## PERCOLATION TESTING

ADDRESS Farside, Lot 63, Foxspur Court PHONE (301) 483-9631

RE: Percolation Certification Plan

Purpose: Relocate/revise existing approved sewage disposal area  
Property ID: Foxspur – Lot 63  
Foxspur Court

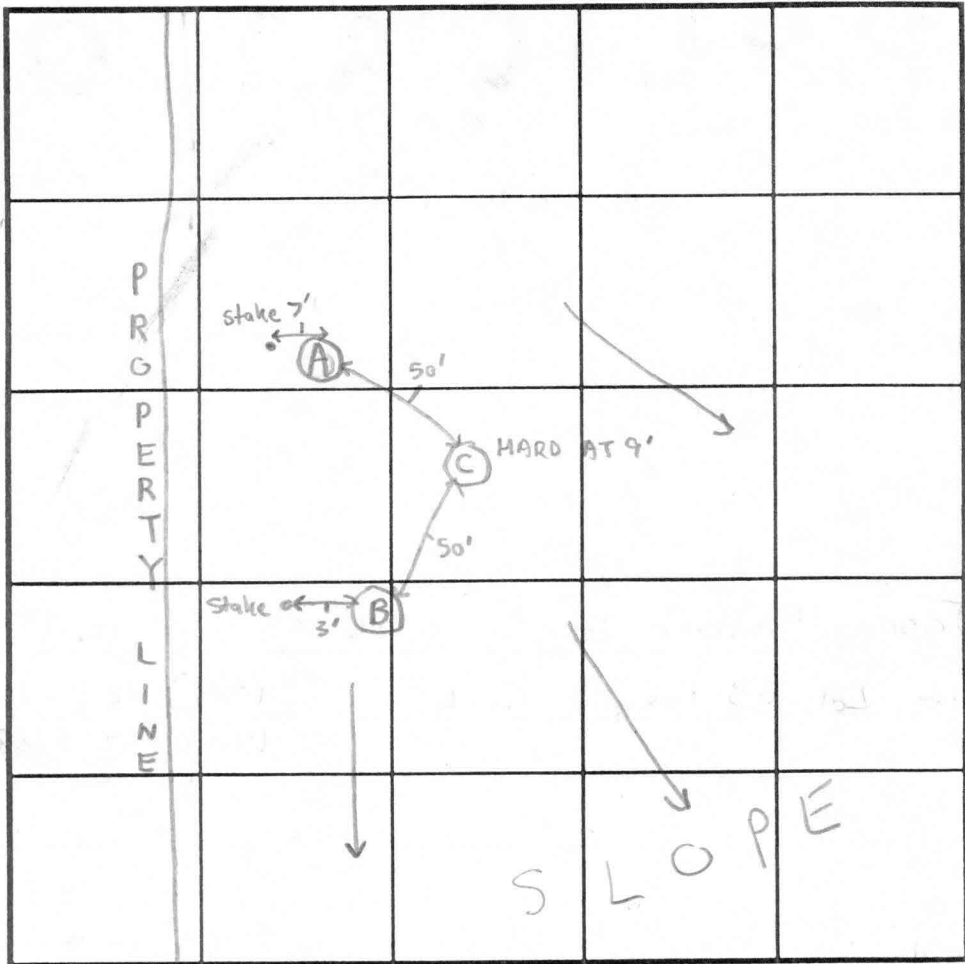
DATE	TEST NO.	DEPTH	PRE-WET		TEST - 1" DROP		TIME
			START	STOP	START	STOP	
10/13/00	A	3' S	10:11am	10:13am	10:13am	10:15am	2min
		11 1/2' V	(VISUAL OK)		SEE	PROFILE	
	B	2' 9" S	10:26am	10:27am	10:27am	10:30	3min
		13' 8" V	(VISUAL OK)		SEE	PROFILE	
	C	9' V	CHARD	BOTTOM	BUT	IF TRENCH	OK
			BOTTOM IS		4'-5'	ENOUGH	
			SOIL		BUFFER	EXISTS	OK

REMARKS Soil consistent, Best to keep shallow system

TYPE OF SOIL \_\_\_\_\_  
 TESTED BY Steven R. Krieg ALSO PRESENT Chuck Zepp - Contractor  
Mr. Soubier - Owner  
 TRENCH DESIGN DATA: AVERAGE PERCOLATION TIME 2.5 min TRENCH WIDTH 3  
 INLET DEPTH 2 MAXIMUM BOTTOM DEPTH 4 SQ. FT./BEDROOM 180
